RE: Case 18-02P, Final Development Plan & Construction Drawings for Wynstead Section 5 A & B

On the agenda for March 6th meeting is Case #18-02P, an application for approval of the Final Development Plan & Construction Drawings (FDP) Wynstead Section 5 Phases A & B (the “Property”) submitted by Grand Communities, LTD (aka Fischer Homes) (the “Owner”).

Attached are our comments after reviewing the Wynstead Subdivision Section 5, Phases A & B subdivision plans, the storm calcs for the roadway storm sewer, and the construction estimate that were submitted to Choice One on 2/5/18. Choice One recommends that the plans and supporting documentation be resubmitted after revisions are made. An electronic resubmission of the revised items would be acceptable to Choice One.

1.0

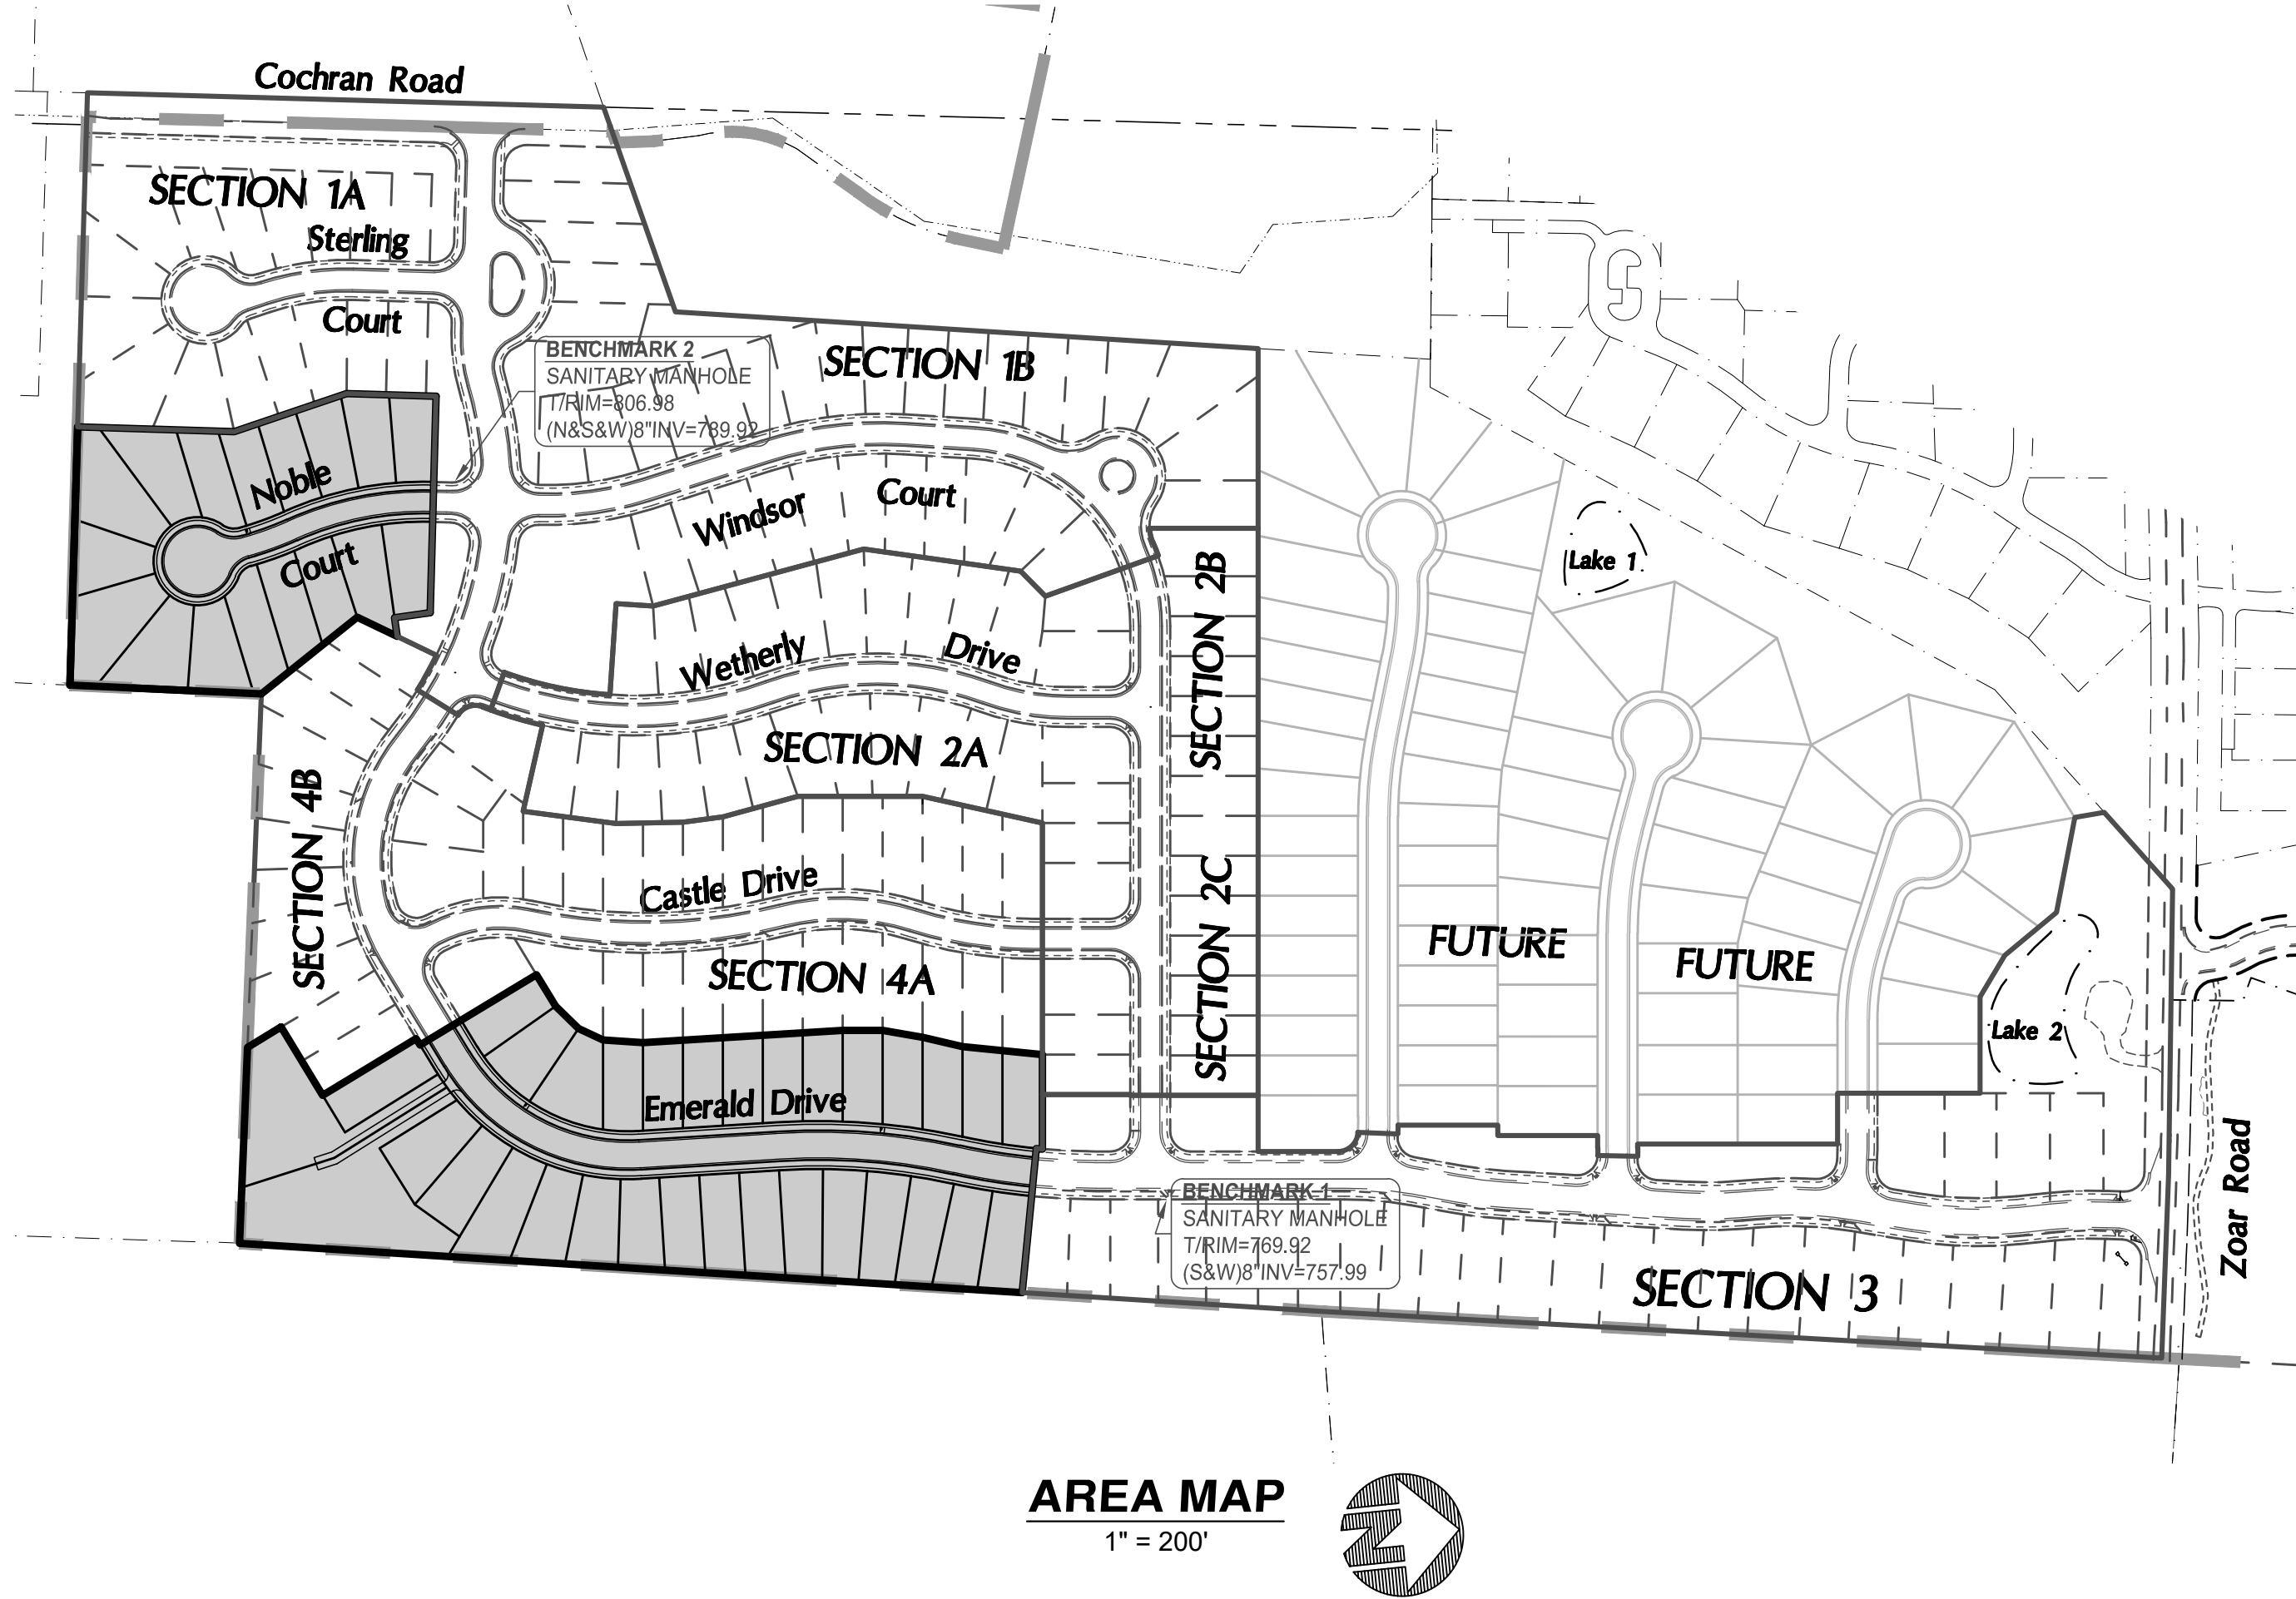
- General
 - o Please add Warren County sanitary sewer details to plans.
- Page 1.0
 - o A field visit determined that the sanitary manhole at the corner of Noble and Emerald (benchmark #2) was buried under the grass. Please locate and confirm benchmark prior to use as project survey control.
- Page 2.0
 - o Sump drains shall be 6" minimum (change labels on plan view too)
 - o Asphalt surface and intermediate courses are mistakenly referencing ODOT Item 442 Superpave asphalt. Please revise to reference Item 441 asphalt.
 - o Note on curb detail that final surface course to be 1/4" higher than gutter plate.

5.0

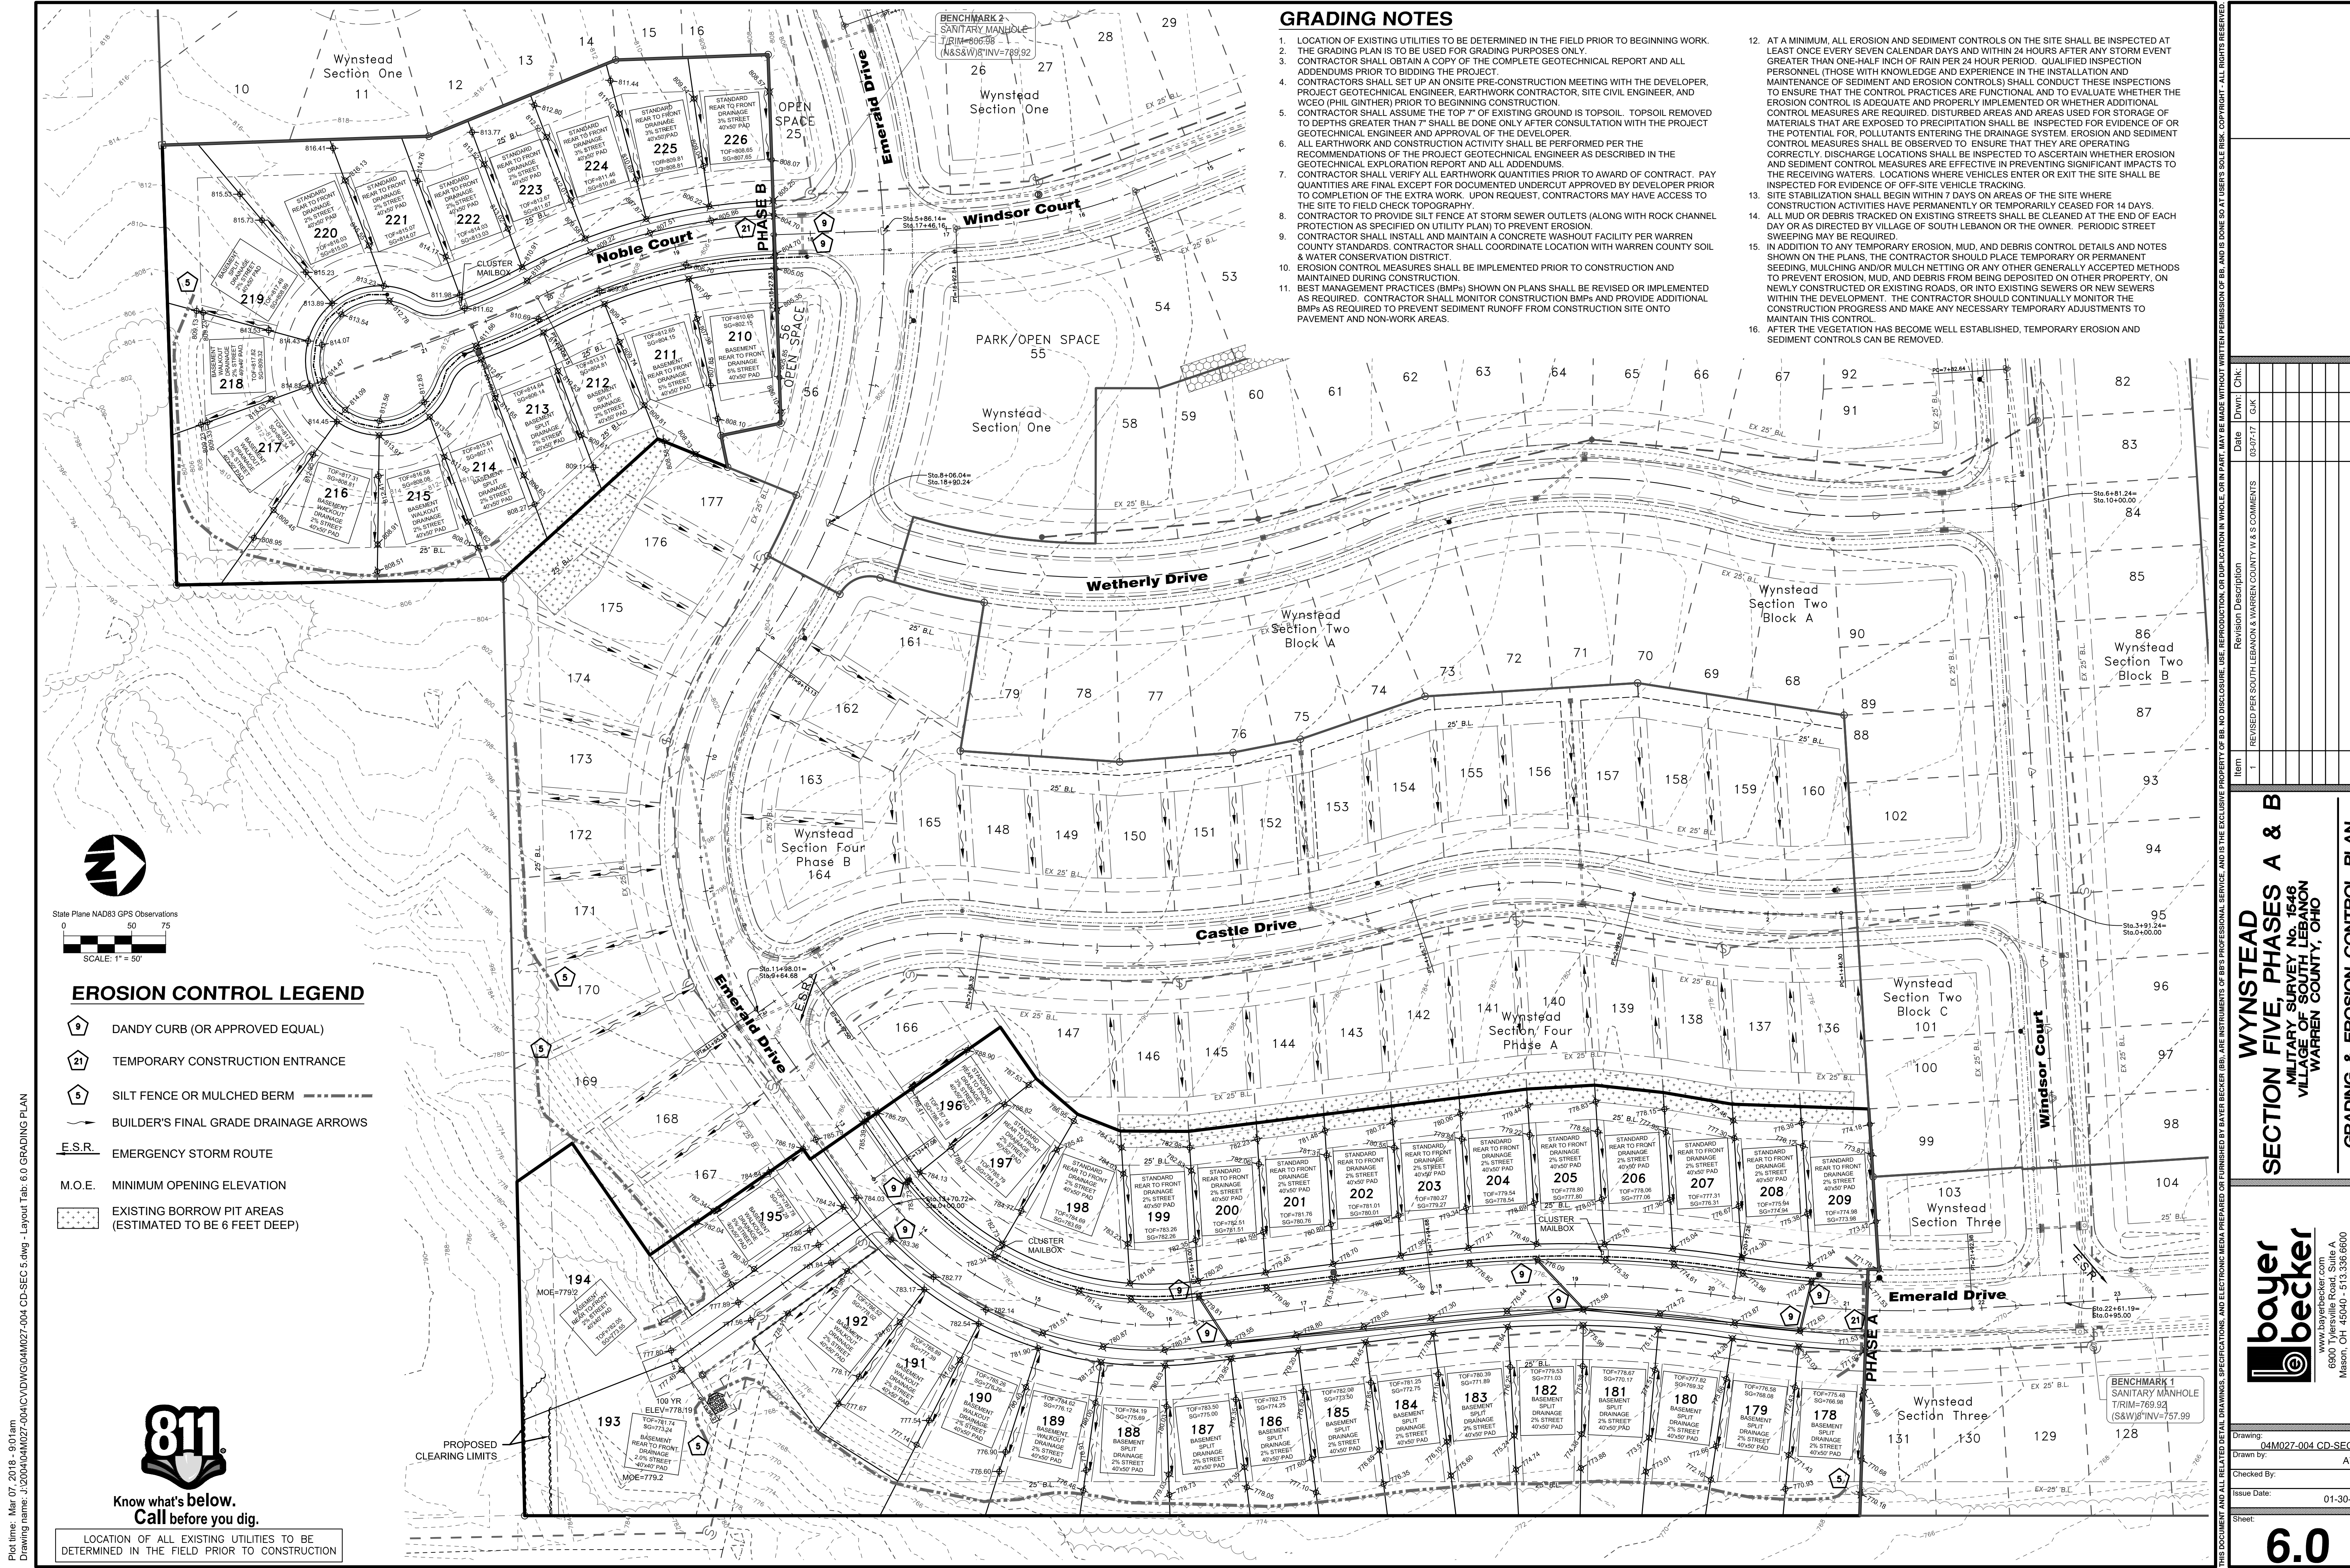
- Page 5.0
 - o Emerald Drive sewer in phase 5A is shown as existing. Please send plans that were to be built "by others" to Choice One.
 - o Extend 4" water main in Noble Court cul-de-sac further so the blow off valve is in front of lot 220. This will eliminate the need for the water service to cross the entire cul-de-sac.
- Page 6.0
 - o On Note 14, change reference of Warren County to "Village of South Lebanon".

- 1) The water main on Noble Court terminates at the valve, the temporary fire hydrant was never installed.
- 2) As the plans are shown all water main testing will be against existing valves. Confirm developer understands there is potential for failed pressure tests.
- 3) Noble Court watermain should continue around cul-de sac to lot line 220/221.

Revision Description: REVISED PER SOUTH LEBANON & WARREN COUNTY W & S COMMENTS
